UNITED STATES
NUCLEAR REGULATORY COMMISSION
WASHINGTON, D. C. 20555

The Commission has issued the enclosed Amendment No. 65 to Facility Operating License No. DPR-31 and Amendment No. 58 to Facility Operating License No. DPR-41 for the Turkey Point Plant Unit Nos. 3 and 4, respectively. The amendments consist of changes to the Technical Specifications in response to your applications transmitted by letters dated September 12, 1980 and March 10, 1981.

These amendments revise the Technical Specifications to include a clarification of the term "operable" as it applies to the single failure criterion for safety systems in power reactors and includes an update of the organization chart.

SAFETY EVALUATION BY THE OFFICE OF NUCLEAR REACTOR REGULATION
RELATED TO AMENDMENT NO. 65 TO FACILITY OPERATING LICENSE NO. DPR-31
AND AMENDMENT NO. 57 TO FACILITY OPERATING LICENSE NO. DPR-41
FLORIDA POWER AND LIGHT COMPANY
TURKEY POINT PLANT UNIT NOS. 3 AND 4
DOCKET NOS. 50-250 AND 50-251

PLANT ORGANIZATION CHART
FIGURE 6.2-2

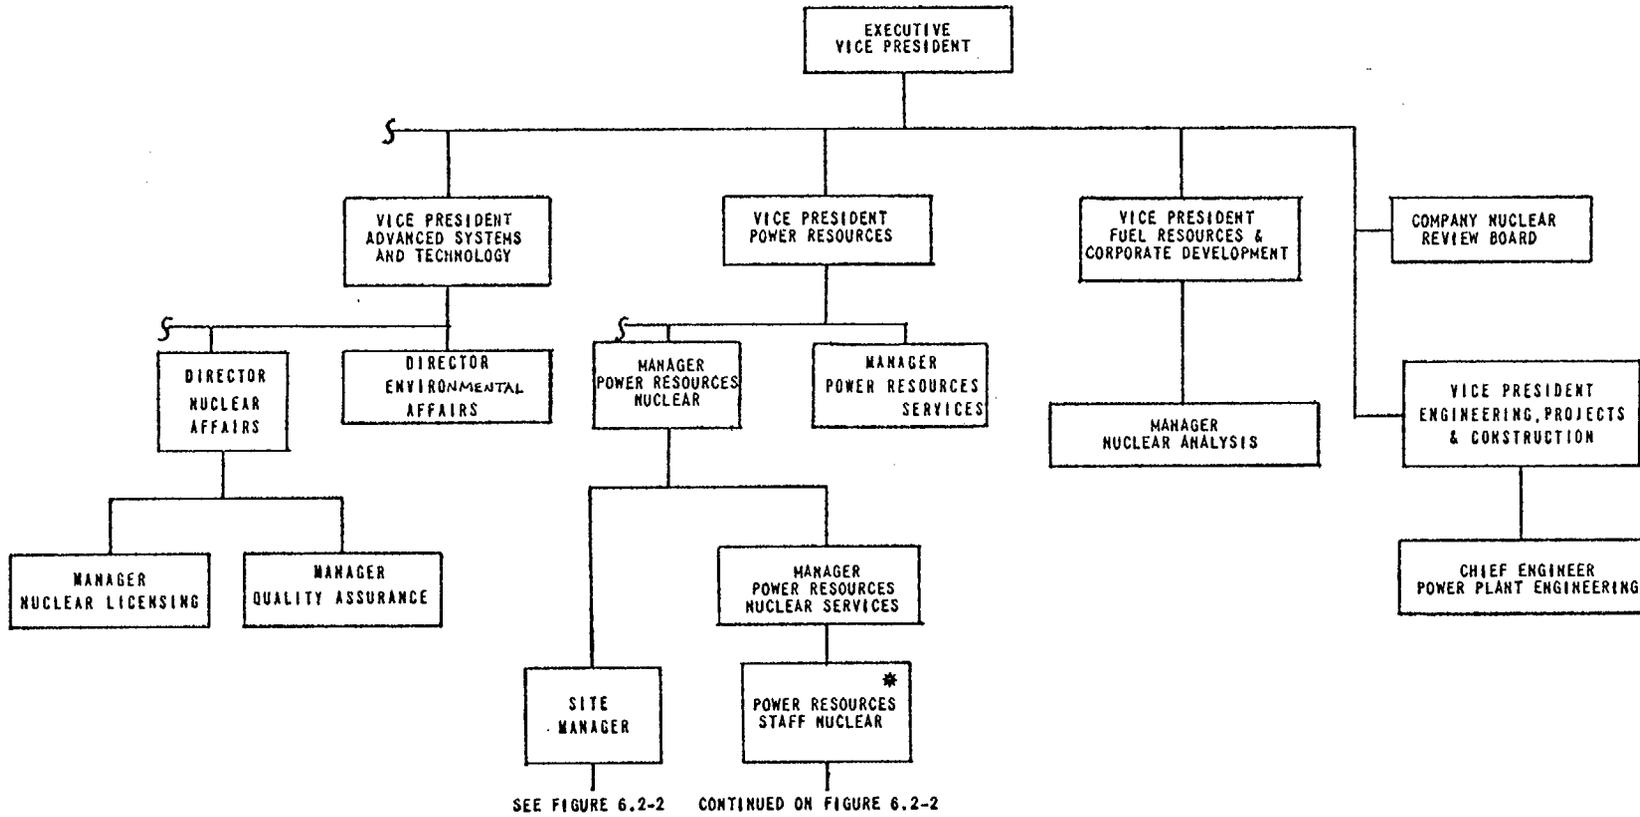
By letters dated September 12, 1980 and March 10, 1981 Florida Power and Light Company (the licensee) submitted applications to amend Facility Operating License Nos. DPR-31 and DPR-41 for the Turkey Point Plant Unit Nos. 3 and 4. The applications requested amendments to the Technical Specifications, Appendix A to the licenses, regarding: (1) a clarification of the term operability as it applies to the single failure criterion for safety systems in power reactors and (2) an update of the organization chart, Figures 6.2-1 and 6.2-2.

Item 2 is a routine update of the organization chart. This is an administrative matter which does not decrease the safety of the plant operation and therefore is acceptable. It will not be evaluated any further.

The Facility organization shall be as shown on Figure 6.2-2 and:
